State of New Mexico
Energy, Minerals and Natural Resources

SUNDRY NOTICES AND REPORTS ON WELLS
(DO NOT USE THIS FORM FOR PROPOSALS TO DRILL OR TO DEEPEN OR PLUG BACK TO A DIFFERENT RESERVOIR. USE "APPLICATION FOR PERMIT" (FORM C-101) FOR SUCH PROPOSALS.)
1. Type of Well: Oil Well [X] Gas Well [] Other []
2. Name of Operator EOG RESOURCES INC
3. Address of Operator PO BOX 2267 MIDLAND, TX 79702
4. Well Location Unit Letter J : 1650 feet from the SOUTH line and 2310 feet from the EAST line
Section 16 Township 23S Range 31E NMPM County EDDY

Medano VA State #10 – P&A Procedure

API # 30-015-32044

Proposed Wellbore Diagram:

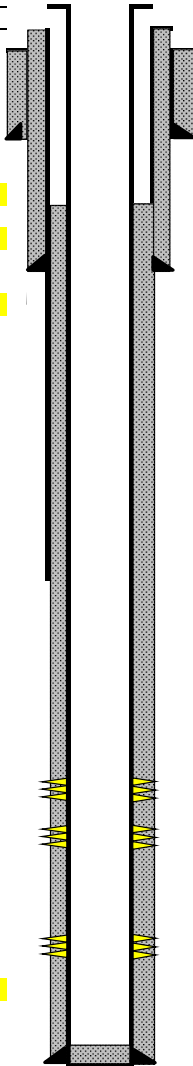
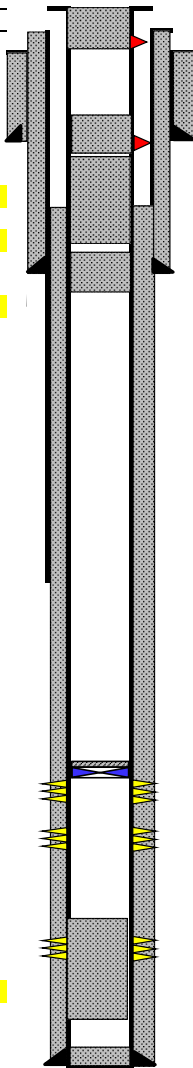
See Changes to Plugging Plan

A CBL must be run and submitted to OCD via OCD Permitting.

4. RIH, set **CIBP @ 7786'** w/ 15sx Class H -WOC & Tag - Bone Spring formation top.
5. RIH to set CIBP at 6320 TAG and pressure test **casing 500psi/30 minutes. Run CBL if one not available**

6. Circulate plugging mud
7. Top CIBP w/ 25 sx Class C on CIBP
8. **Spot 15 sx cmt 5180' - 5080' - T Cherry Canyon**
9. Pick up, set balanced plug w/ 25 sx Class C from 4318 to 4066 for -50' below Intermediate Shoe.
